Access Compliance Report
Public Rights-of-Way
(Curb Ramps)

Intersection ID: 17009	Main Street: N_WENDOVER_RD	Cross Street: RANDOLPH RD	Location:	W
ADA ID: 6CDD0CDF3312	Ramp Type: Perp	Initial Pass/Fail: Fail	Overall Compliance: No	Severity Score: 33.75

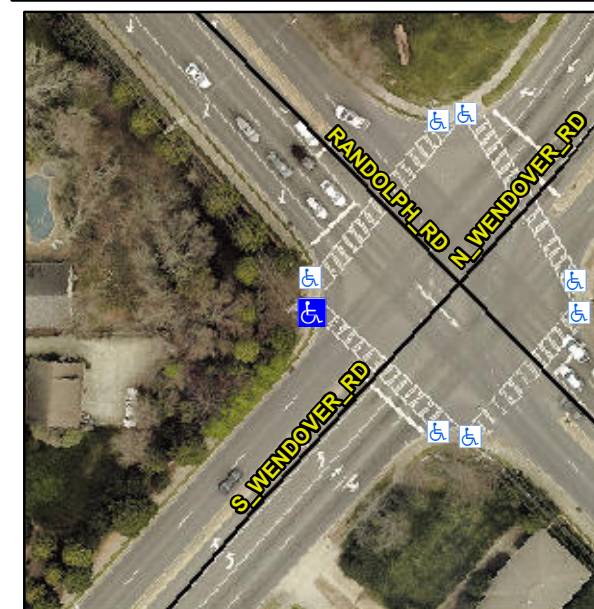
Not Found, R304.5.1, R304.5.3

Compliance	Description	Data	Compliance	Description	Data
N/A	Ramp Length (in)	81.0	Yes	Ramp Slope (%)	6.6
No	Ramp Width (in)	42.0	No	Ramp XSlope (%)	8.5
N/A	Flare Type LT	N/A	N/A	Flare Type RT	N/A
N/A	Flare Slope LT (%)	N/A	N/A	Flare Slope RT (%)	N/A
N/A	Flare Traversable LT?	N/A	N/A	Flare Traversable RT?	N/A
N/A	Landing Length (in)	N/A	N/A	DWS Provided?	N/A
N/A	Landing Width (in)	N/A	N/A	DWS Contrast?	N/A
N/A	Landing Slope (%)	N/A	N/A	DWS Length (in)	N/A
N/A	Landing X Slope (%)	N/A	N/A	DWS Full Width?	N/A
N/A	Landing Curb? (Y/N)	N/A	N/A	DWS Offset (in)	N/A
N/A	Shared Landing?	N/A			
N/A	Gutter Ponding?	N/A	N/A	Gutter Slope (%)	N/A
N/A	Gutter Lip Ht (in)	N/A	N/A	Gutter X Slope (%)	N/A
N/A	Painted X Walk1?	Yes	N/A	Painted X Walk2?	N/A
	X Walk 1 Direction	To SE		X Walk 2 Direction	N/A
N/A	X Walk 1 Width (in)	87.0	N/A	X Walk 2 Width (in)	N/A
	X Walk 1 Slope (%)	6.3		X Walk 2 Slope (%)	N/A
	X Walk 1 X Slope (%)	1.5		X Walk 2 X Slope (%)	N/A

Remove & Replace Entire Ramp.
